Addendum 1
Solicitation 24-99434
HILLSIDE CULVERT REPAIRS

HILLSIDE CULVERT REPAIRS

TEMPORARY STREAM DIVERSION DETAILS
SHEET NO. 52 OF 52 SHEETS

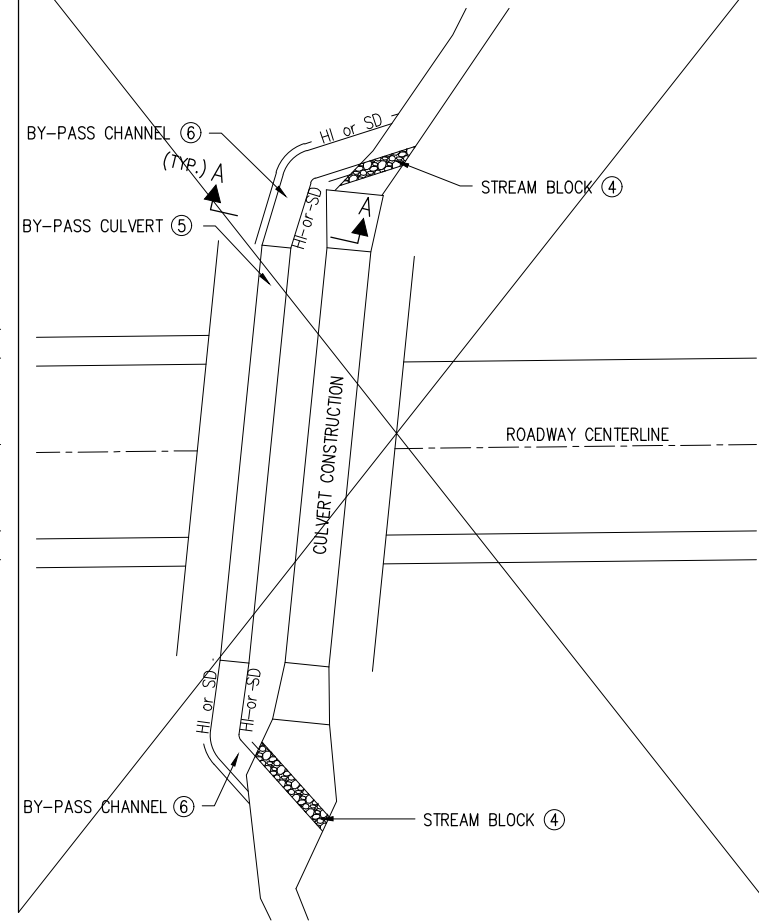
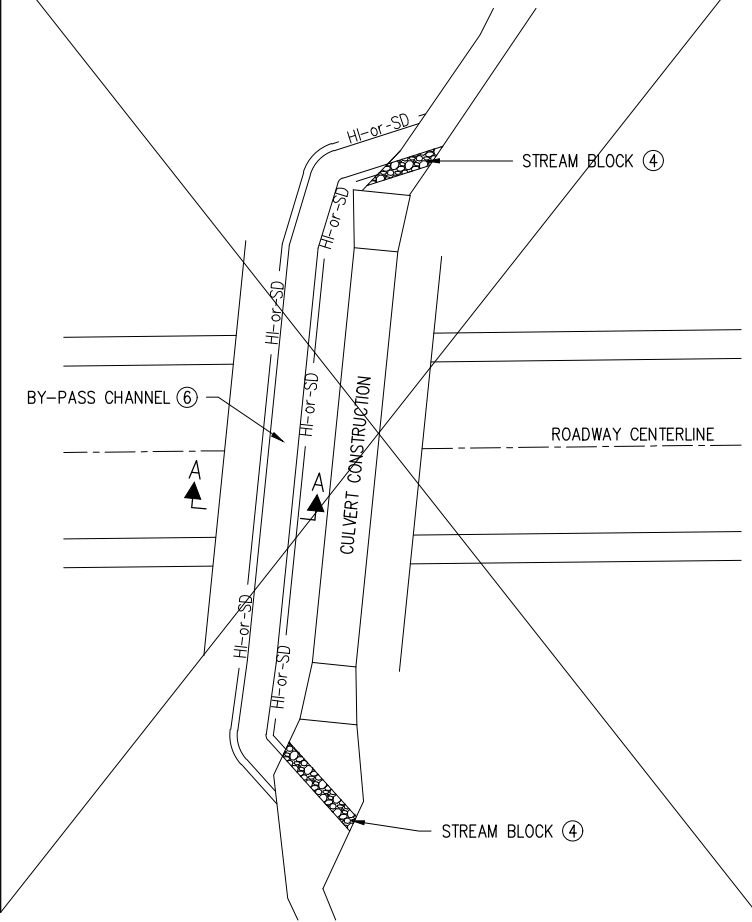
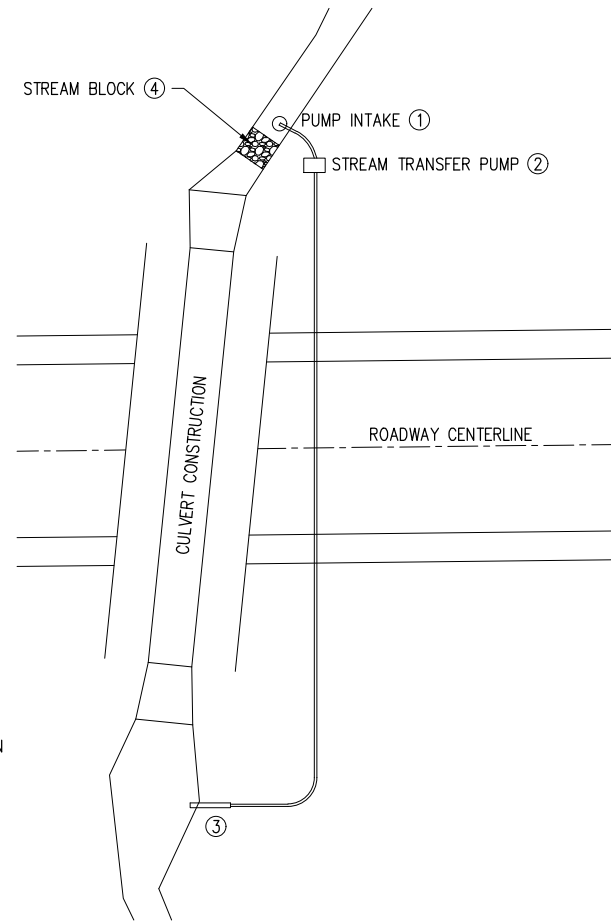
1. Sheet 52; Delete Sheet 52 in its entirety and replace with revised Sheet 52. Revisions to Sheet 52 are as follows:
 - a. Revision to Temporary Stream Diversion flow requirements.

- ① PUMP INTAKE SHALL UTILIZE A SUMP OR BE FITTED WITH SCREEN AND FLOATING HEAD (PREFERRED).
- ② STREAM TRANSFER PUMP SHALL BE SIZED TO ACCOMMODATE EXPECTED DAILY FLOWS AT REPAIR LOCATIONS.
- ③ DISCHARGE THROUGH FLOCCULENT SOCK.
- ④ STREAM BLOCK. CONTRACTOR SHALL BE RESPONSIBLE FOR DESIGN AND CONSTRUCTION OF STREAM BLOCK AND ITS PERFORMANCE TO FULLY FUNCTION, NON-ERODIBLE, AND TO ACCOMMODATE EXPECTED DAILY FLOWS AT REPAIR LOCATIONS. CONTRACTOR SHALL SUBMIT METHOD AND DETAILS TO ENGINEER PRIOR TO CONSTRUCTING.
- ⑤ BY-PASS CULVERT TO BE TEMPORARY CULVERT PLACED IN ROAD CUT OR JACKED THROUGH PRIOR TO CUT. CULVERT SHALL BE SIZED FOR A MINIMUM 2 YEAR - 24 HOUR EVENT AT THIS CROSSING.
- ⑥ BY-PASS CHANNEL TO BE CONSTRUCTED AS SHOWN ON THIS PAGE. CHANNEL SHALL BE SIZED FOR A MINIMUM 2 YEAR - 24 HOUR EVENT AT THIS CROSSING.
